RESIDENTIAL PLAN CORRECTION SHEET

ADDENDUM TO Permit No. 01242
Owner WALTER J. TRUCKHALL
Contractor LEE B. BUNCKER
Location 60 YOLLETTE

FIELD CORRECTION NOTICE

Brief Description of Work: ----- SCREENED IN PORCH

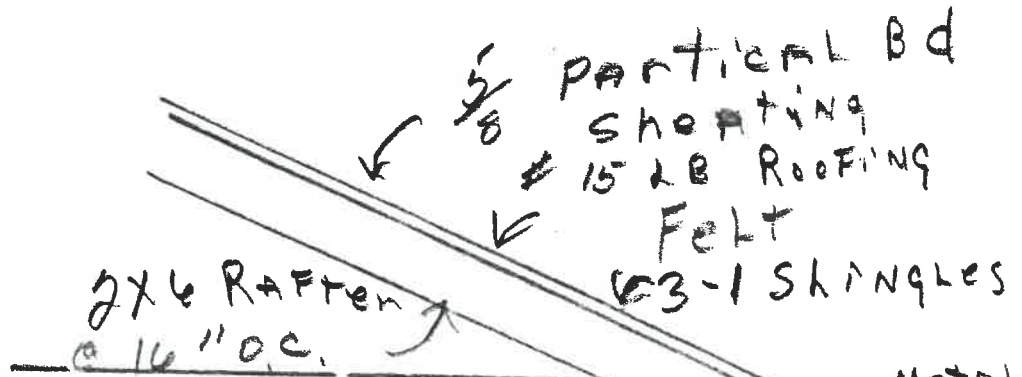
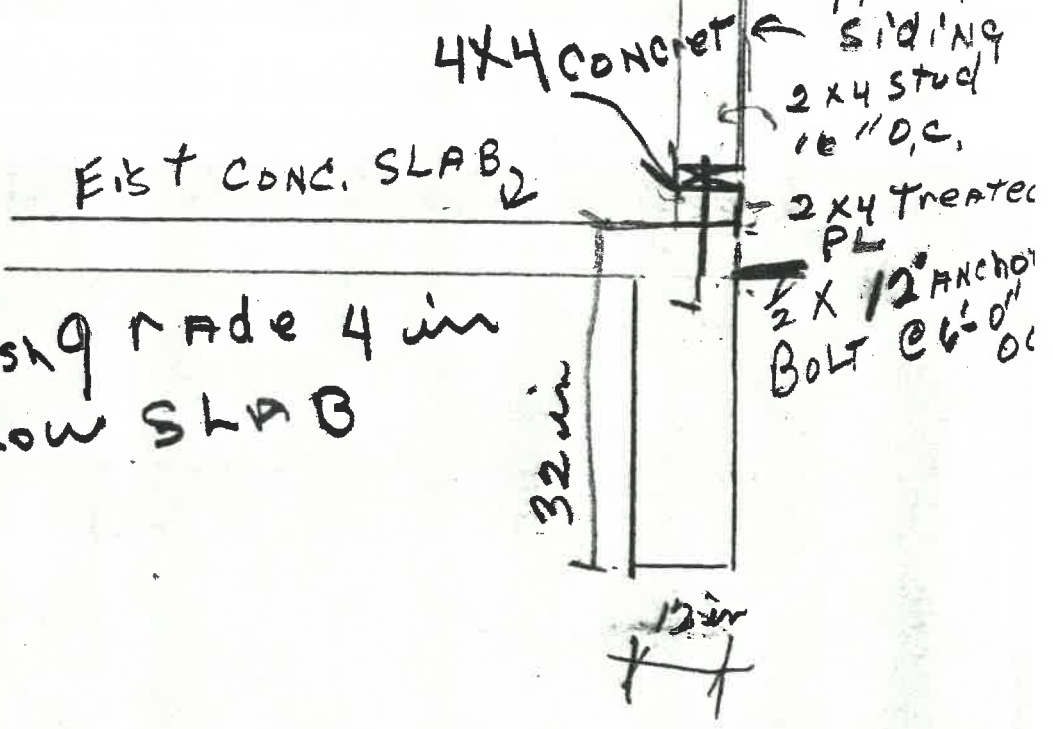
AOD SOLID FULL HT. 2X BLOCKING
BETWEEN CEILING JOISTS ABOVE
WALL PLATE & BELOW ~~CEILING~~ RAFTERS

AOD SOLID 2X BLOCKING
